Re: Fuel System Upgrades
Clark County Airport
Clark, South Dakota
AIP #3-46-0009-017-2024
Helms #A-9350

ADDENDUM NUMBER 1

DATE: May 31, 2024
PROJECT: Fuel System Upgrades
Clark County, South Dakota
DGR Project No. 733701

ADDENDUM NO. 1

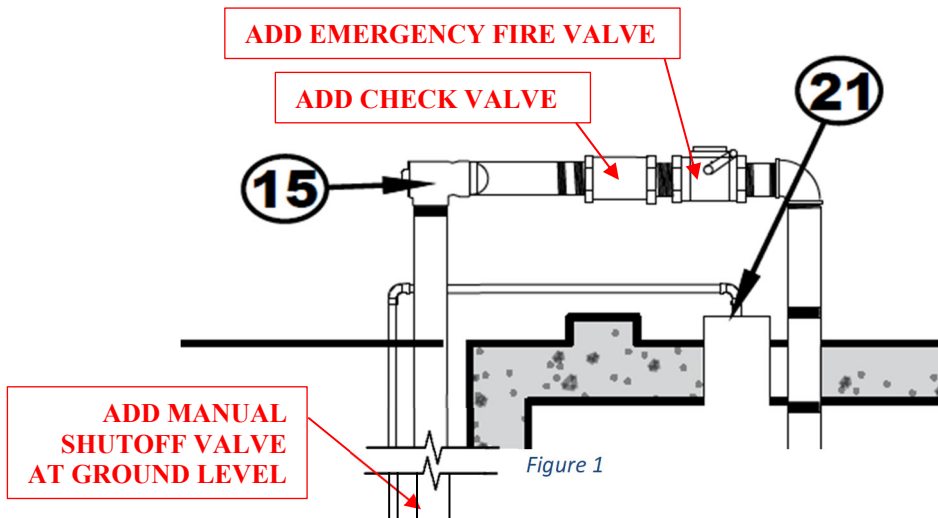
Sheet E8 (Details – 5,000 Gallon 100LL Avgas Cylindrical Tank – Side Elevation). Add components as indicated and revise as shown in Figure 1 below.

Sheet E8 (Details – 5,000 Gallon 100LL Avgas Cylindrical Tank – Side Elevation). Revise Keynote #1 (Suction Piping) text callout to: CUT PIPE 9" FROM TANK BOTTOM.

Sheet E8 (Details – 5,000 Gallon 100LL Avgas Cylindrical Tank – Side Elevation). Remove Keynote #12 label.

Sheet E8 (Details – 5,000 Gallon 100LL Avgas Cylindrical Tank – Tank Keynote #5). Revise keynote to: 6-INCH PRIMARY EMERGENCY VENT.

Sheet E8 (Details – 5,000 Gallon 100LL Avgas Cylindrical Tank – Tank Keynote #6). Revise keynote to: 3-INCH PRESSURE/VACUUM VENT.

Sheet E8 (Details – 5,000 Gallon 100LL Avgas Cylindrical Tank – Tank Keynote #12). Remove keynote.

Sheet E8 (Details – 5,000 Gallon 100LL Avgas Cylindrical Tank – Tank Keynote #14).
Revise keynote to: 3-INCH OVERFLOW PREVENTION VALVE.
